## <u>Town Planner's Project Review</u> Wednesday, September 25, 2024

- VIII. <u>280 Durham Point Road. 2-lot Subdivision</u>. Subdivision of 33.5 acre parcel into a 5 acre lot to contain an existing house and a 28.5 acre lot intended for acquisition by The Nature Conservancy. Dick and Kathleen, Gsottschneider, Gsottschneider Family Trust, property owner. Ben Wallace, The Nature Conservancy, applicant. Valerie Shelton, Real Estate Agent. Adam Fogg, Surveyor. Map 227, Lot 36. Residence Coastal and Rural Districts.
- I recommend that the Planning Board approve waivers possibly subject to any appropriate conditions as part of an approval, accept the application as complete, schedule a public hearing for October 9, and decide whether or not to hold a site walk.

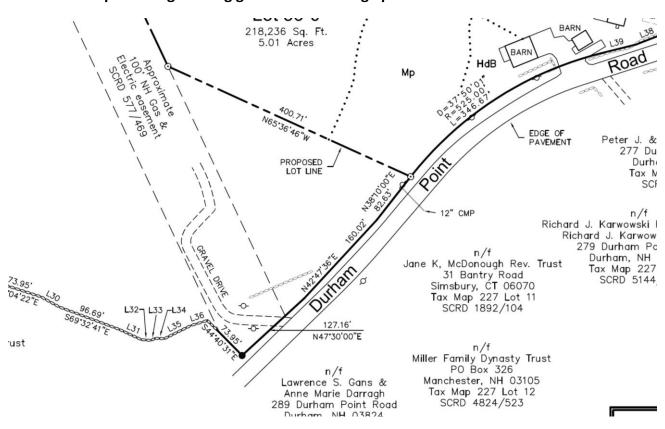
- 8) Wetlands. The applicant notes on the application that there are wetlands on site but does not indicate where they are. The Town's very general Wetlands map from the 2015 Master Plan shows a possible wetland (hydric soils in green which may or may not be wetlands) at the front of the large parcel. As part of any subdivision approval there will need to be a clear method for how access will be gained to the new parcel. See map at the bottom. Durham Point Road is shown in black.

What does TNC need for access? It's a full gravel road that runs to the left of the powerline. Is the existing road sufficient? Large trucks use it for powerline equipment maintenance, when the upgraded the lines a few years ago and when Richard has done any logging operations. Would they have permission to use it? TNC would own it... Eversource just has an easement.

It would probably not be adequate for a developer to use for access nor for a single-family house. The current gravel road would make the most logical place of entry... it's existing and has the best line-of-site and resembles the driveways across the road that run along the power lines. Where would they take access? It's a road that crossed under the power line easement onto Durham Point. Eversource uses the same road. Is there a wetland there? Yes, but there is already a crossing with a culvert. We have a 100-foot buffer for wetlands. You can cross but need a conditional use. Do grandfathered crossings count? Richard may be able to speak better to this especially since work was done with the Town in regard to moving the road.

## Revised map showing existing gravel drive on large parcel:

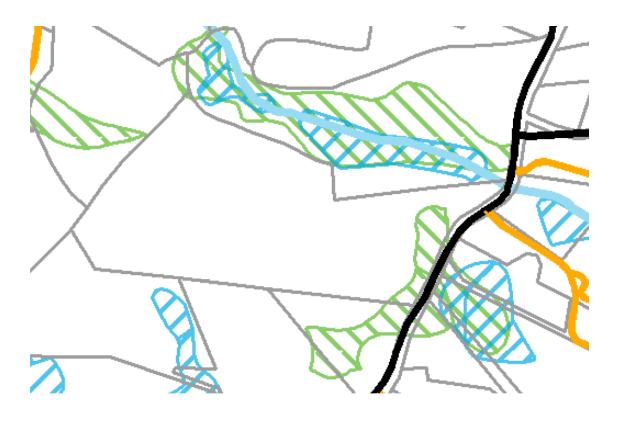
It looks like there may be a wetland in front. If so, access would probably have to go through the Gsottschneider lot with an easement and all that goes with that. That would not work... you'd be using the same driveway which has poor line-of-sight and runs in between the existing buildings out through an agricultural field, up through a wooded hillside, down through another agricultural pasture, and then across the 100' powerline easement. The wetland map you provided does not show the existing road which runs from Durham Point up into the proposed lot.

We will need to see how sight distance is for the new lot. Again, it's an existing access road which has been maintained for many decades. Would it be possible for you to take a ride by the property prior to the meeting? I think it will be pretty self-explanatory and you will agree makes the most logical point of entry, especially it's not going away given Eversource also uses it.
